The Evolution of the Consulting Arborist into a Design Professional

TREE PROTECTION AND RECOMPENSE PLANS ATLANTA BELTLINE WESTSIDE TRAIL (SEGMENT 4)			
DESIGNED	DATE:	DRAWN	DATE:
REWORKED	DATE:	CHECKED	DATE:
APPROVED	DATE:

•→29-100¶

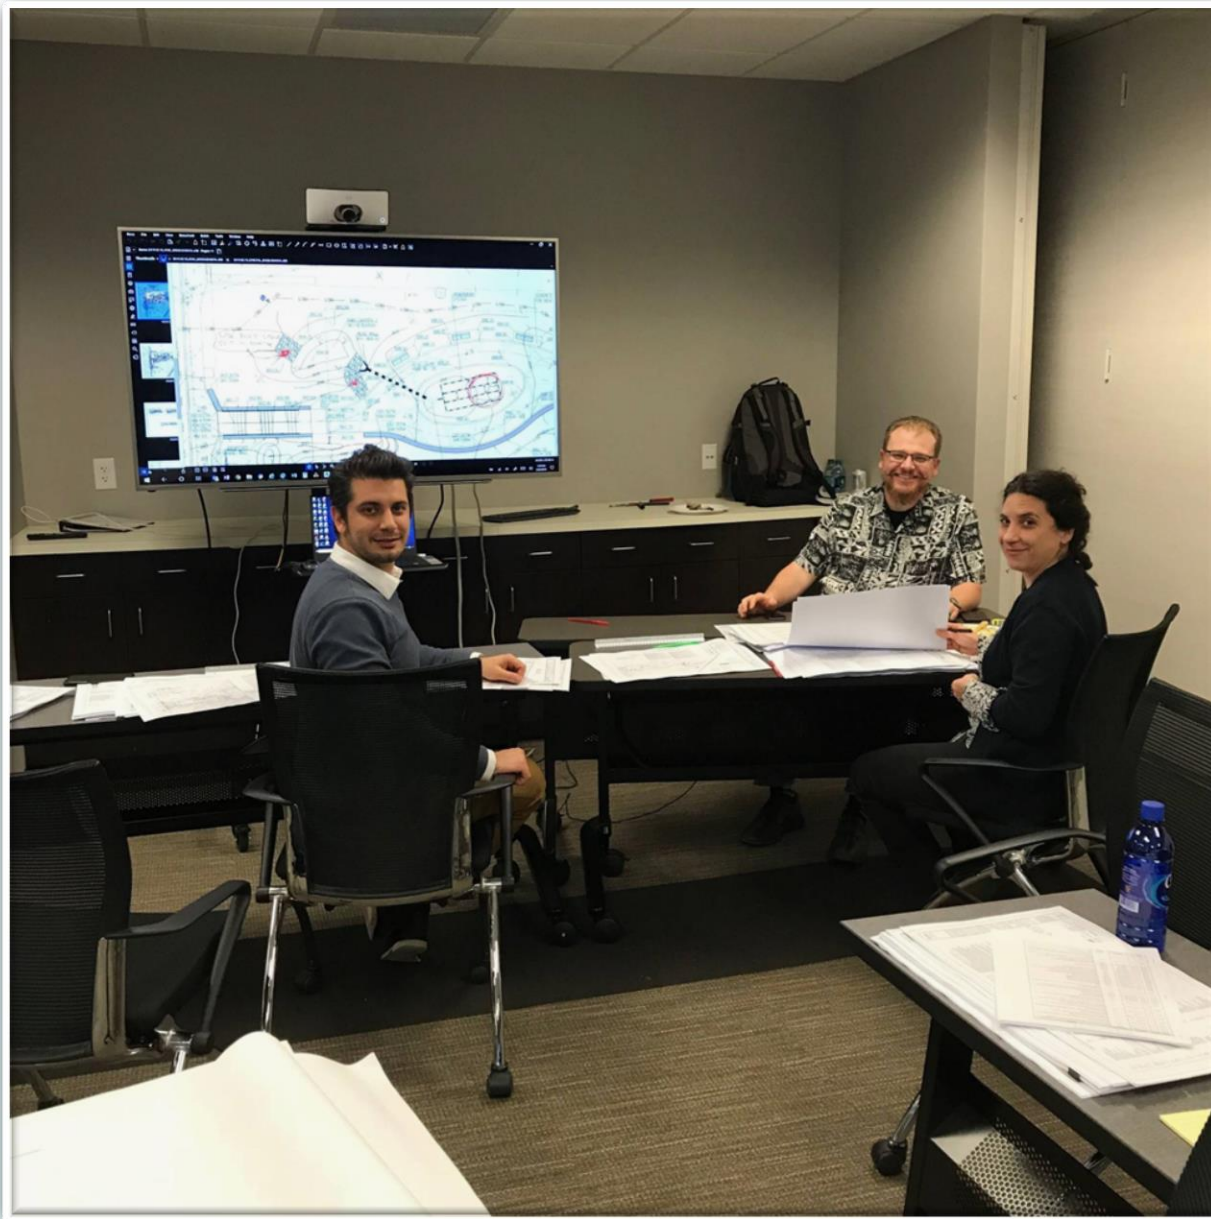
- Availability of the trees in the Metro Atlanta area Questionable¶
- Water Hickory¶
- Bluff Oak¶
- Southern Shagbark Hickory¶
- No Green Ash should be planted, Emerald Ash Borer is killing them¶
- Sand Post Oak¶
- Carolina Buckthorn¶
- Persian Ironwood¶
- Post Oak¶
- American Bladdernut¶
- Horse Sugar¶

This note needs to be added to this page:¶

Since all trees shown are specified as container grown trees, all trees are to be inspected by an ISA certified arborist BEFORE the containers are to be removed from the shipping vehicle. NO EXCEPTIONS. ¶

All container grown trees shall meet the American Standard for Nursery Stock ANSI Z60.1-2004. As per Section 1.7 on page 20 of the document, all trees shall be free of excessive circling roots. Trees found with excessive irreparable girdling root conditions will be rejected before being off-loaded. NO EXCEPTIONS. ¶

DRAWING No. **29-003**

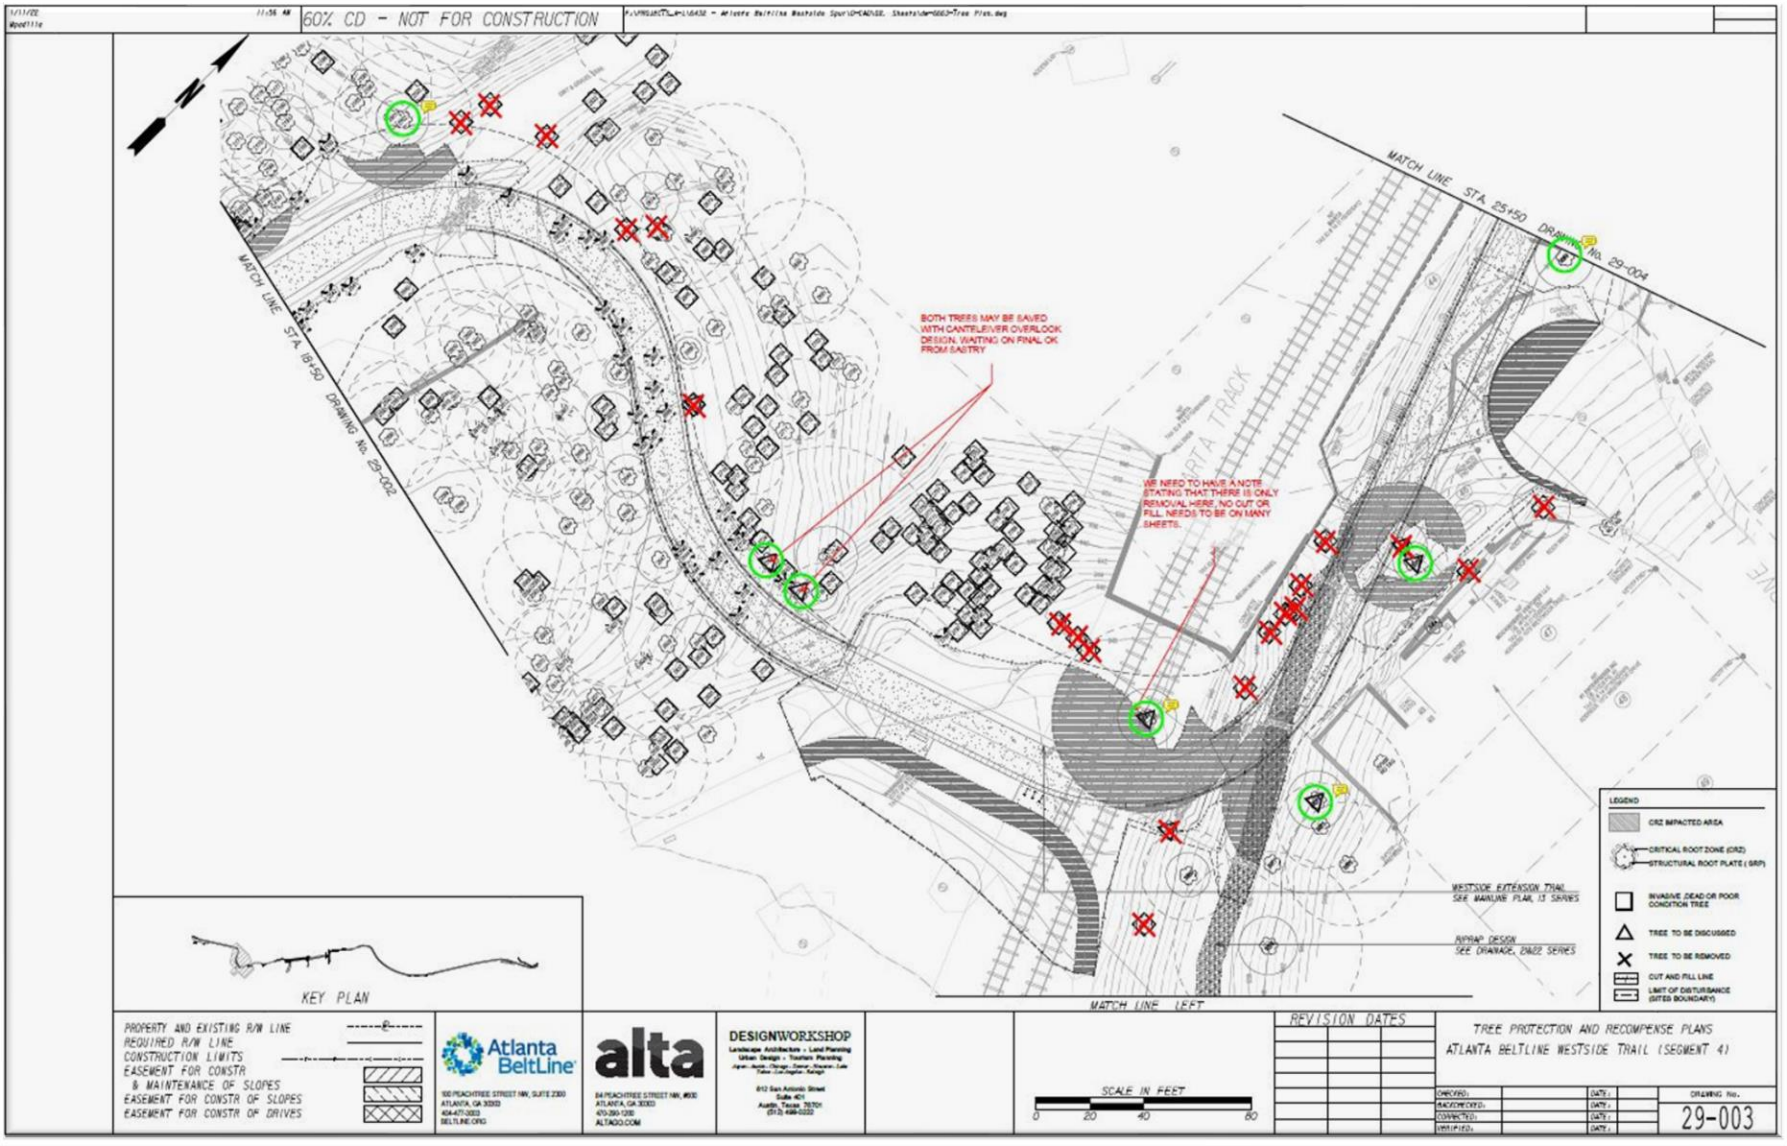
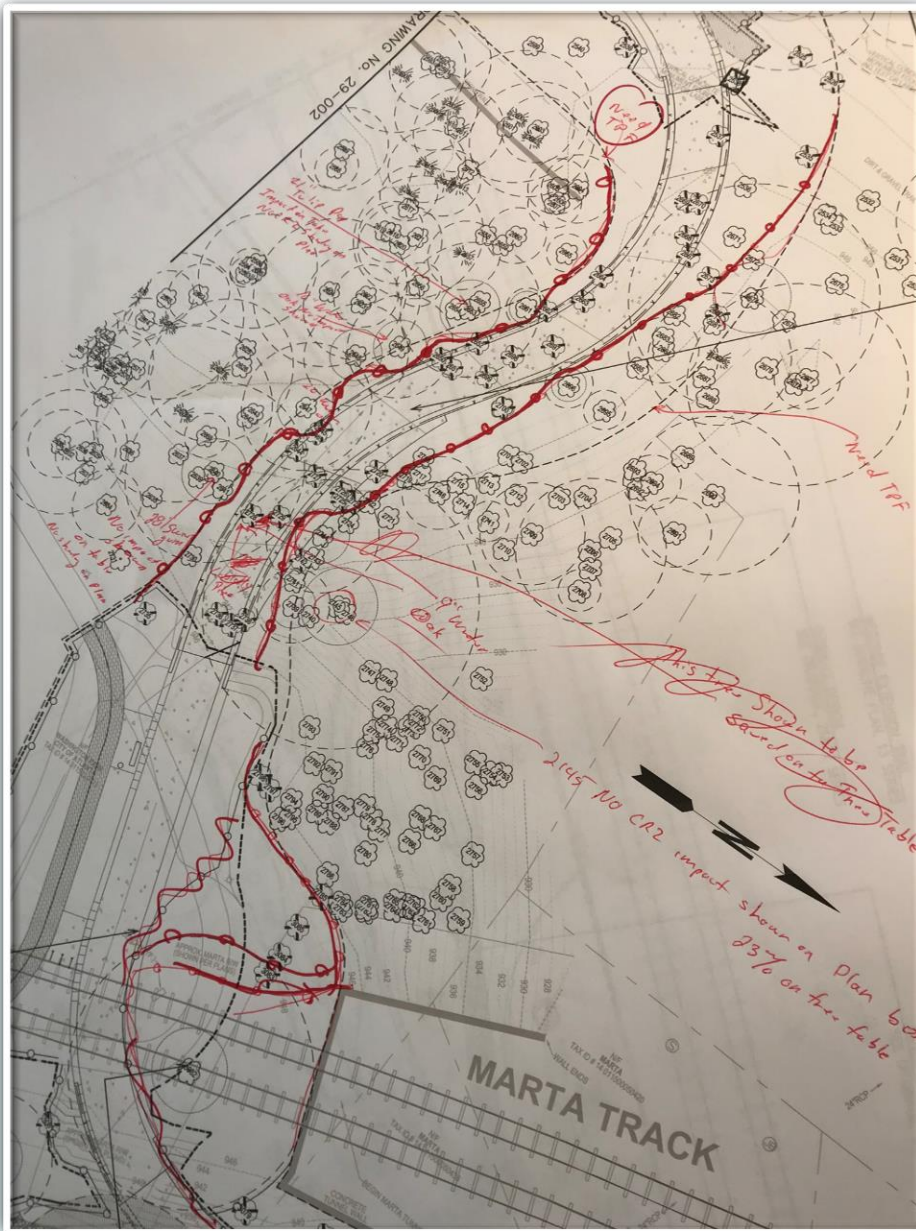
- o → Accuracy is critical when dealing with the City of Atlanta Parks Department plan reviewers, it is strongly recommended that someone on this team go thru this table with the plan and **accurately one tree at a time mark the poor, dead and invasive trees with the box symbol on the plan and correct if needed any deficiencies on the tree table, no exceptions to this will be acceptable anywhere on the 29 plan series.**

¶ General note: every sheet in this series has significant inconsistency regarding the symbol for poor, dead and invasive trees. Some trees have the symbol while most trees that should have the symbol do not. **It is critically important that this symbol be shown on all trees in the 29 Series that require this symbol, whether they are being removed or not.**

- → 001, ¶
 - o → remove "X" from tree # 301 ¶
 - o → NOTE: Tree # 1906 & 1907 will be removed and relocated on-site, to read " will be relocated on-site, remove "X" from both trees use a unique designation for relocated trees. I never identified on the planting plan where these trees are to be located to ¶

- → 002, ¶
 - o → No tree impact shown to CRZ's within the bioswale/riprap area ¶
 - o → # 2004 shown in a bioswale, should it be removed? ¶
 - o → Multiple trees require the DDH symbol ¶

- → 003, ¶
 - o → # 2640 has trees being removed immediately adjacent to it, need a note stating "Tree removal shall not damage adjacent trees to be saved" ¶

- o → # 2745 shown to have a 23% impact in the table, but no shaded CRZ or impact shown on the plan ¶
 - o → # 3078 shows riprap thru a large portion of the CRZ with a 5% impact shown in the table and no root zone impact shown on the plan. Please refer to the details pages in the 21 series set to see how this riprap area is going to be constructed and revise the tree impact accordingly ¶

- o → No tree protection fence shown adjacent to Bridge 1, there will be tree removal and riprap installation under the bridge that will impact the CRZ's of adjacent protected trees. SRP's are to be protected on both sides of the bridge, see attached .jpg of marked-up site plan ¶

- o → Multiple trees require the DDH symbol ¶
- → 004, ¶
 - o → @ # 3031, TPF encroaches into riprap feature (?) ¶
 - o → No TPF @ # 3057, should at least follow the LOD ¶

RFI 622 MSE WALL AT OFFICE T3
4/26/2022

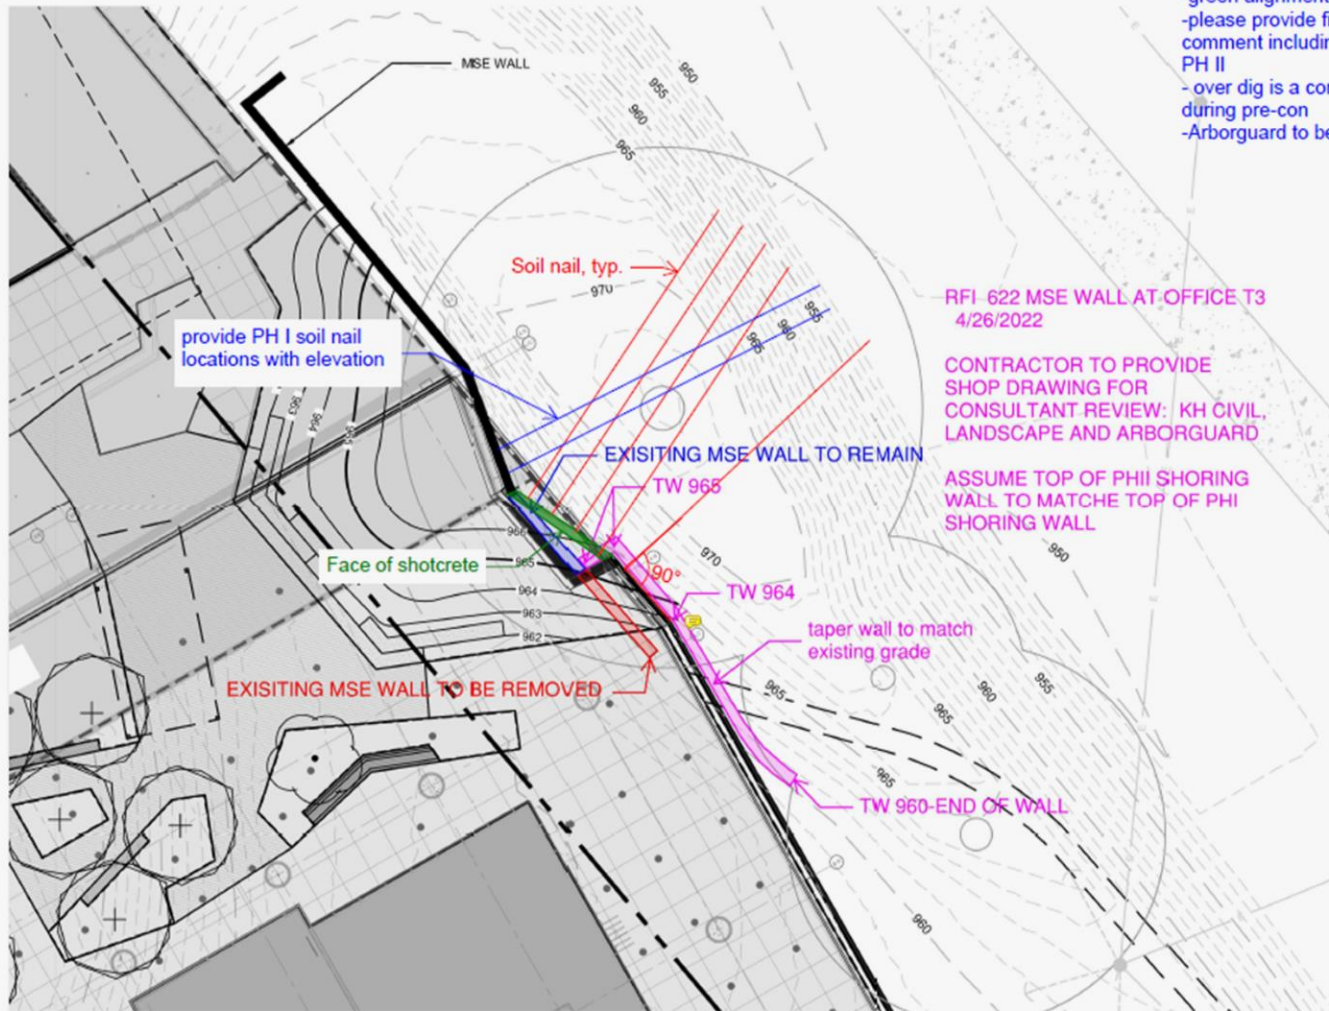
- green alignment is acceptable
- please provide final shop drawing for review and comment including: soil nail elevations for PH I and PH II
- over dig is a concern, limits to be determined on site during pre-con
- Arboguard to be on-site for start of construction

provide PH I soil nail locations with elevation

CONTRACTOR TO PROVIDE SHOP DRAWING FOR CONSULTANT REVIEW: KH CIVIL, LANDSCAPE AND ARBORGUARD

ASSUME TOP OF PHII SHORING WALL TO MATCH TOP OF PHI SHORING WALL
